AGENDA

Date: April 30, 2025

6. Minor Variance Application(s)

Front Elevation Rendering (June 26, 2024) – 26 Holyrood Avenue

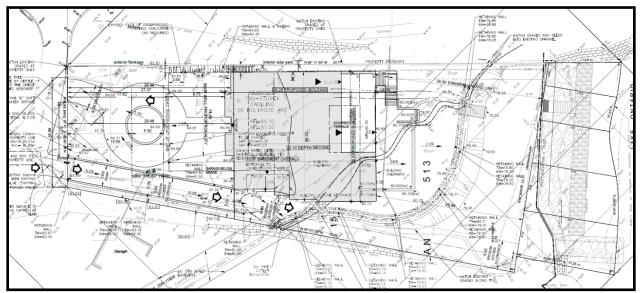
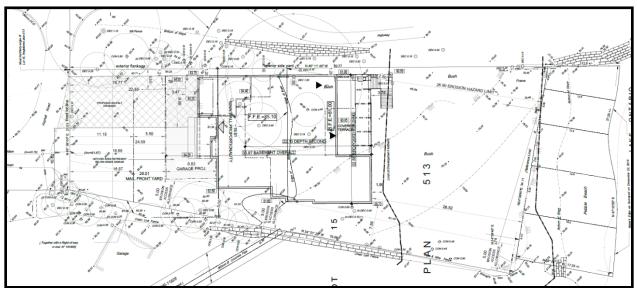
A comparison between the initial proposal heard before the Committee on June 26, 2024, and the revised proposal have been illustrated in the site plan drawing and elevation drawings/3D renderings below.

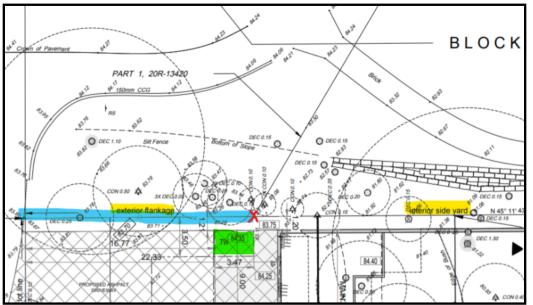
Given the grading of the subject property a portion of the garage, along with a considerable amount of residential floor area, is located in what appears to be the basement level. According to the Zoning By-law definitions of "first storey", "storey", and "grade" however, the basement level has been defined as the first storey, since it has a height greater than 1.8 metres above grade. As such, the proposed development is

classified as three-storeys in height even though it visually appears to be two-storeys when looking at the dwelling from the front. These related variances can be perceived as minor in nature due to the current grading on the lot, which after an initial review from the Town's Development Engineering team cannot be altered, changed, or re-graded.
